REPLACEMENT PROCEDURES OF MODIFID PART
(Shaft : 2mm extended) for the noise from Duplex Unit

99/11/11

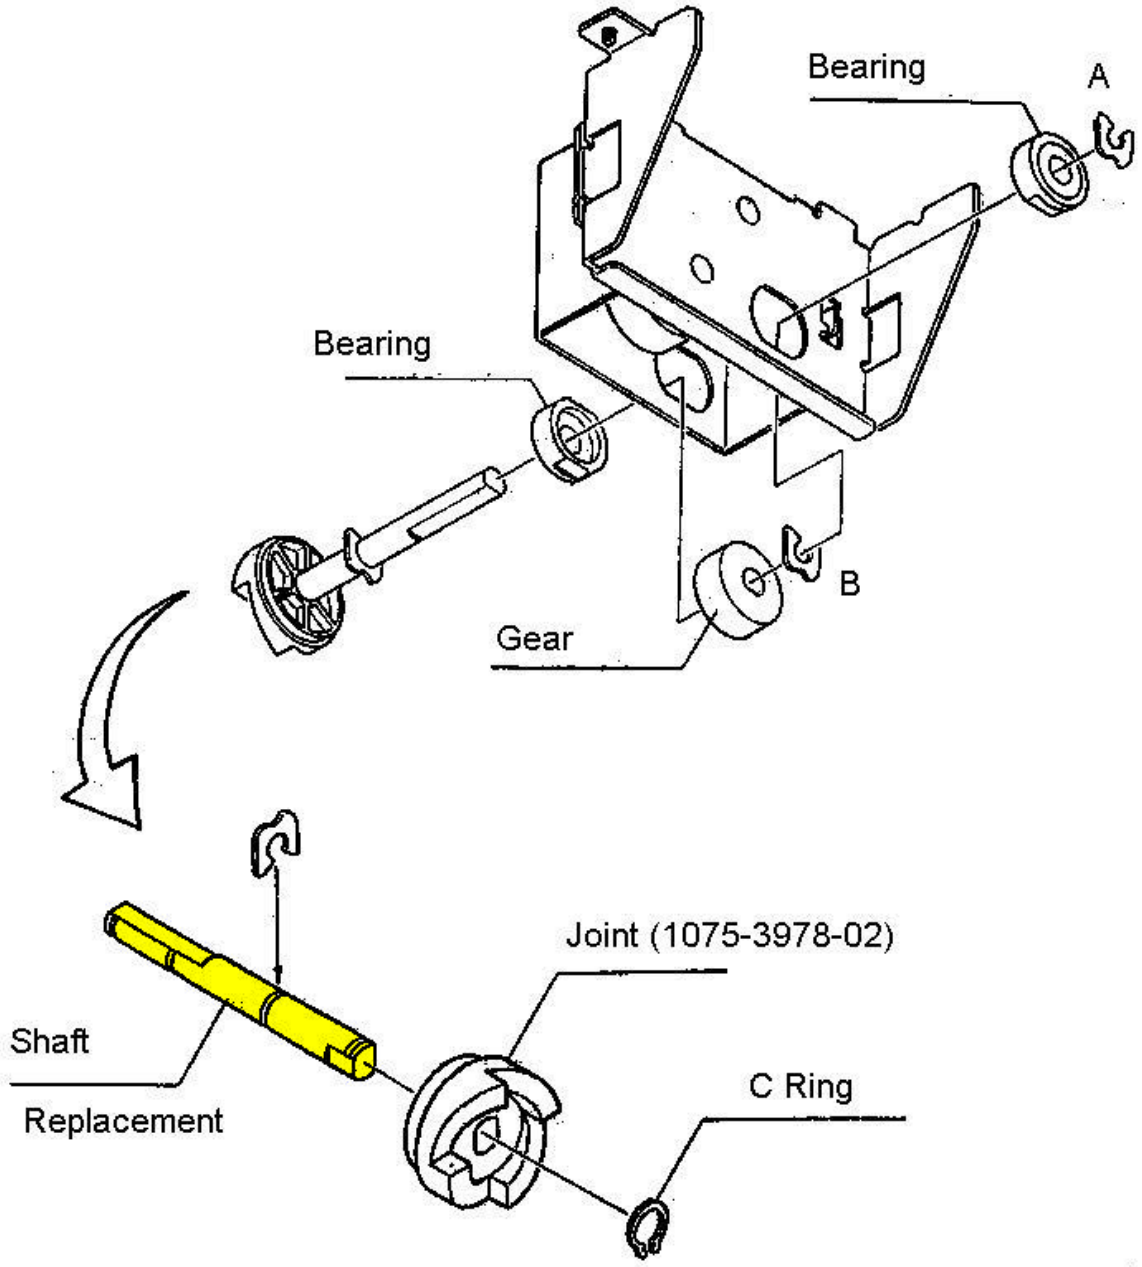
1.Remove the Rear Cover (1155-1003-02).
2. Open the Front Lower Door (1155-1051-02) and slide out the Duplex Unit.
3. Pull out the used Toner Bottle.
4.Replace the Shaft(2mm extended).

1155-5770-02 ->1155-5770-?(itís not set yet.)

1) Remove the E-ring îAî and the Bearing.
2) Remove the E-ring ìBî securing the Gear.
3) Pull out the Shaft.

Opposite order of ìRemoving Proceduresî

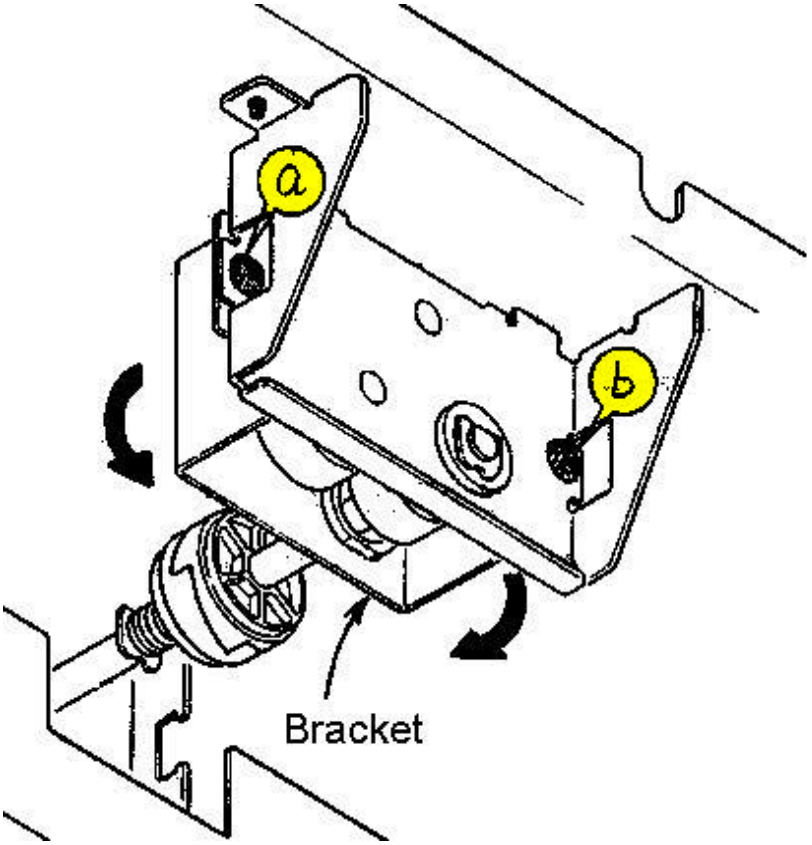
5.Put back the Duplex Unit, and close the Front Lower Door.
6.Make sure that paper is fed correctl y.
7.If noise is still produced, adjust the position of the Bracket.
Loosen thescrews(a,b),and turn Bracket until it doesn't move,and secure it where no noise is produced.
